Model: MZ-R3

No. 518

Subject: Unit powers off during recording/ powers on by itself.

Date: February 11, 1997

[MAIN2 BOARD] (SIDE B)

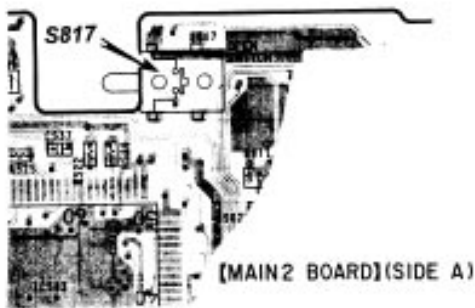
Unit will power off while in record or play back mode, or unit will power on by itself.

Replace S817 (the open switch) and change C825 as described below.

REF	FORMER		NEW	
	DESCRIPTION	PART NUMBER	DESCRIPTION	PART NUMBER
S817	SWITCH, PUSH (1 KEY)	1-572-467-31	REPLACE WITH SAME TYPE	
C825	.01UF CHIP CAP	1-164-118-11	.022UF CHIP CAP	1-115-467-11
